**STATE OF NEW HAMPSHIRE
INTER-DEPARTMENT COMMUNICATION**

AMENDMENT 1

Unity, 2014-M215-20
(DES # 2014-02647)

UNITY
SECOND NH TURNPIKE
M215-20
11/26/2012
BY: JDC
Plan Revisions
01/04/2018 DZP

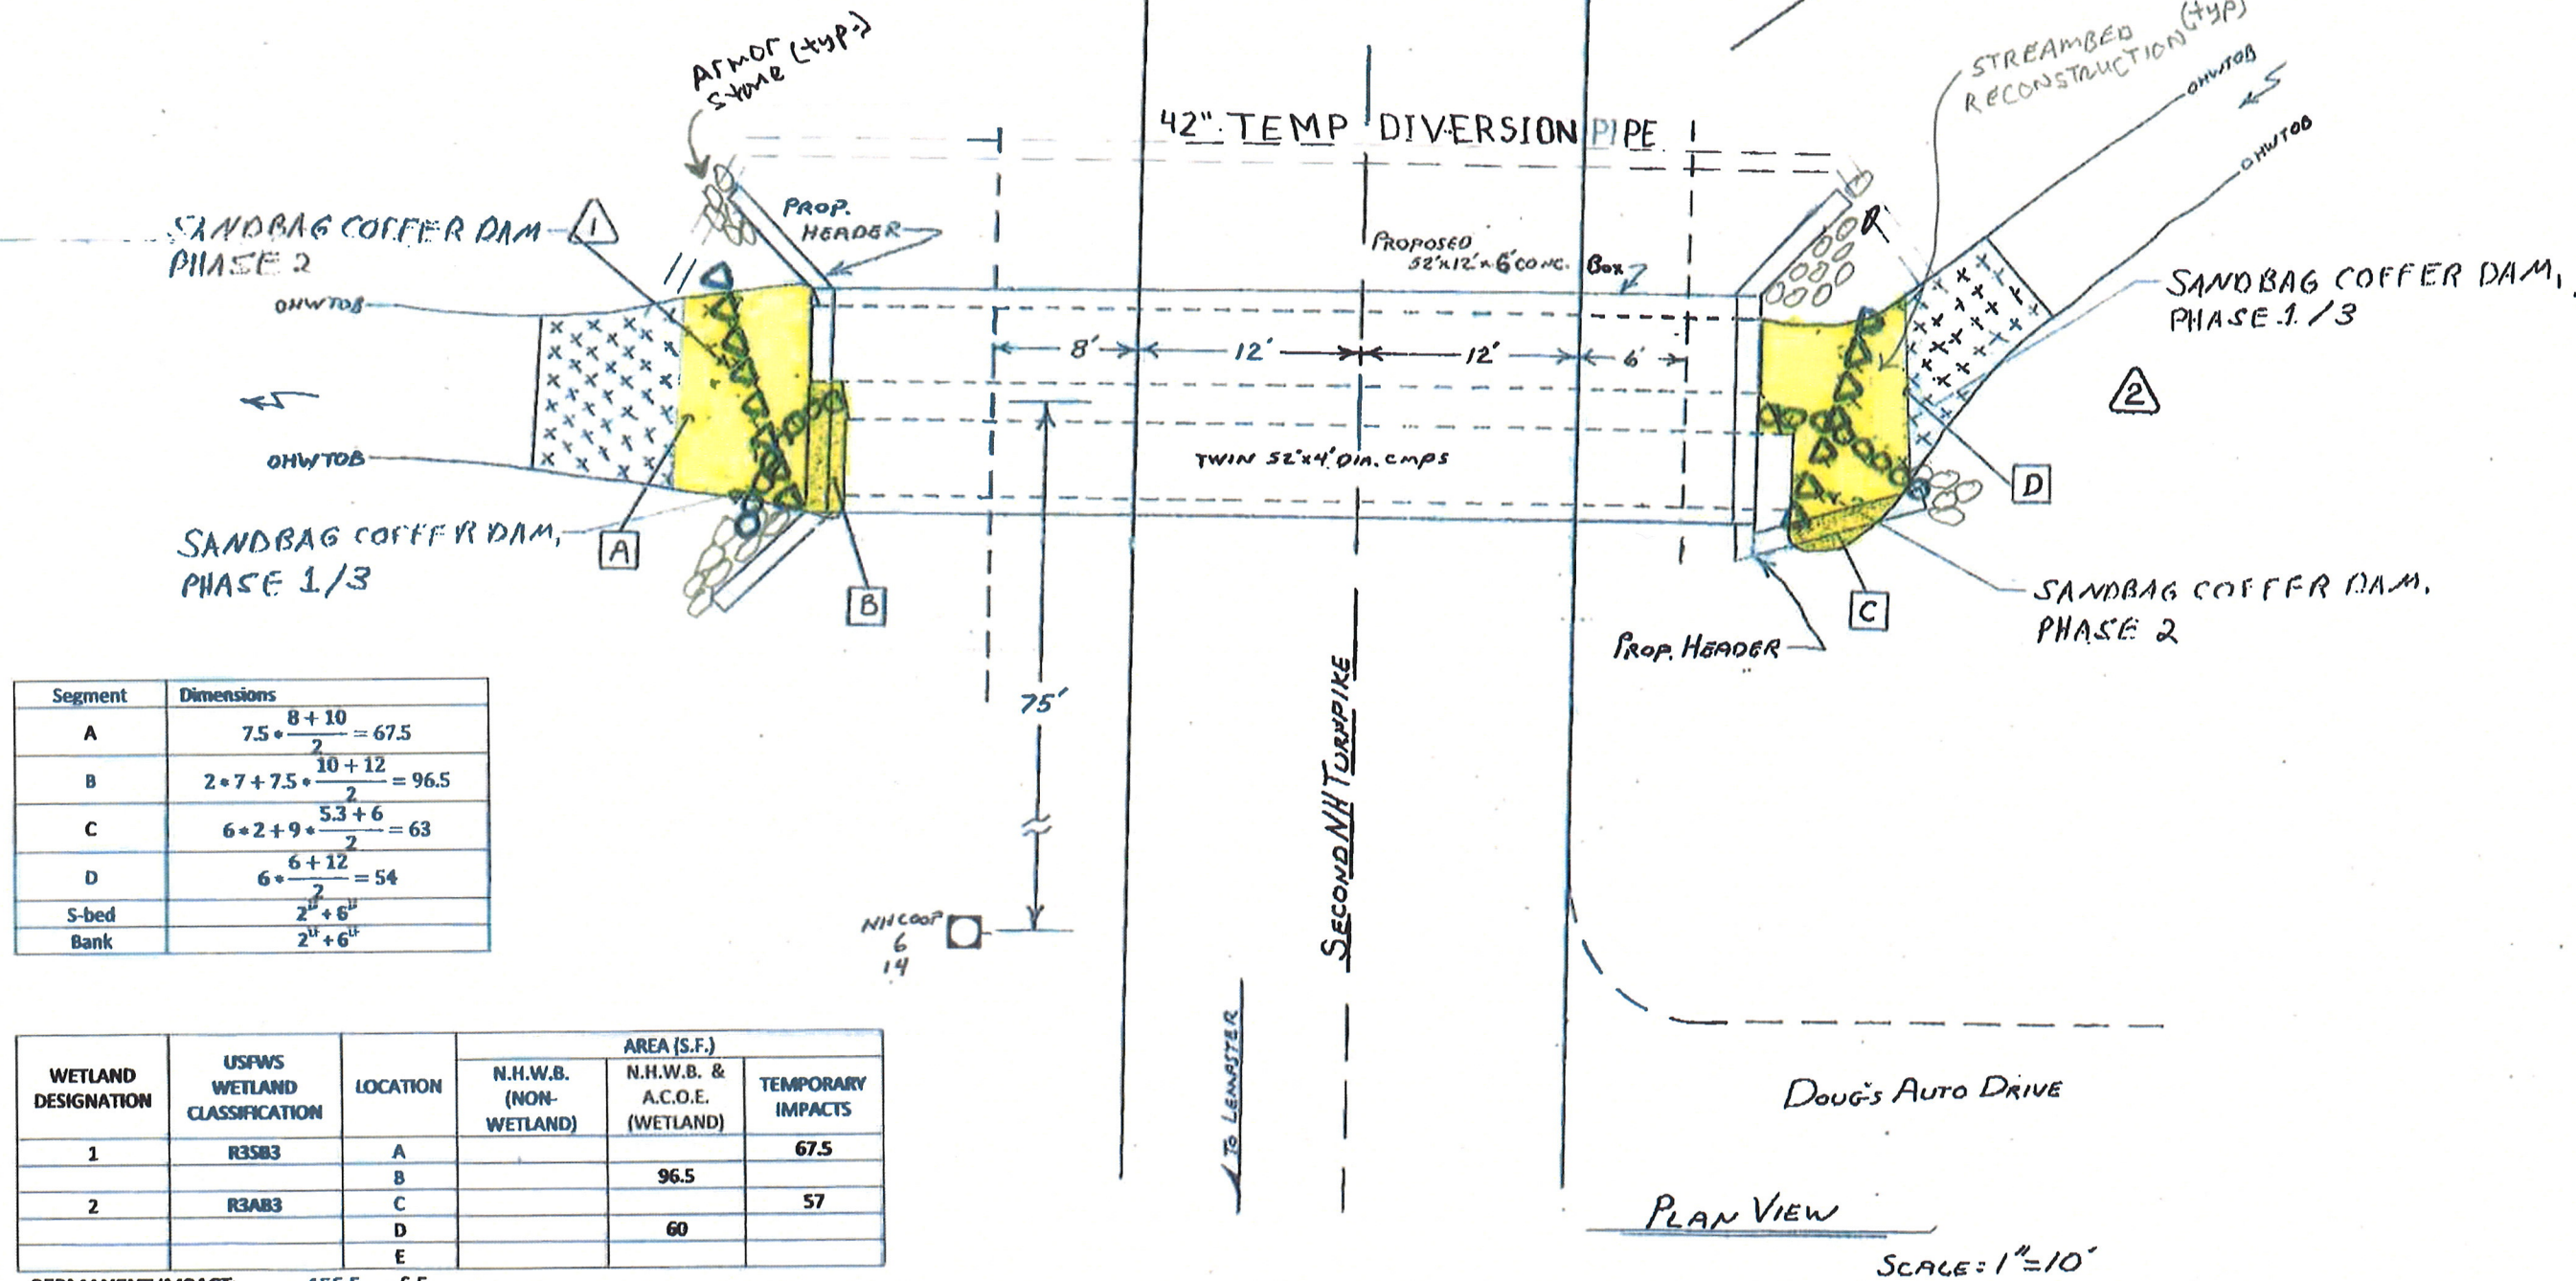
The New Hampshire Department of Transportation (NHDOT) is requesting an amendment of NHDES Permit# 2014-02647. The need for the proposed amendment is to allow our District forces to place approximately 8 LF of stone apron at the inlet and outlet of the proposed box culvert for scour protection. The permitted application had previously shown this area as all temporary impacts; the Department has revised the plan to show the areas of proposed stone apron as a permanent impact. This does not result in any change to impact totals. It only converts impacts previously shown as temporary to permanent. Impact changes can be seen on the revised impact summary table included on the revised plan sheet dated 1/4/2018. It should be noted that stone aprons did previously exist in the areas that they are proposed. However, much of the original stone aprons have washed away over time and only some stone can still be seen in the photos that were provided in the original application. As the proposed stone will be placed where stone has previously existed no mitigation is proposed at this time. This amendment request is also proposing to increase the size of the temporary diversion pipe from a 24" pipe to a 42" pipe to ensure that it can accommodate the hydraulic demand that this diversion will need to maintain our ability to work in the dry. The Department is also proposing to shift the temporary diversion pipe from the easterly side of the crossing to the westerly side to accommodate the construction of the proposed box structure.
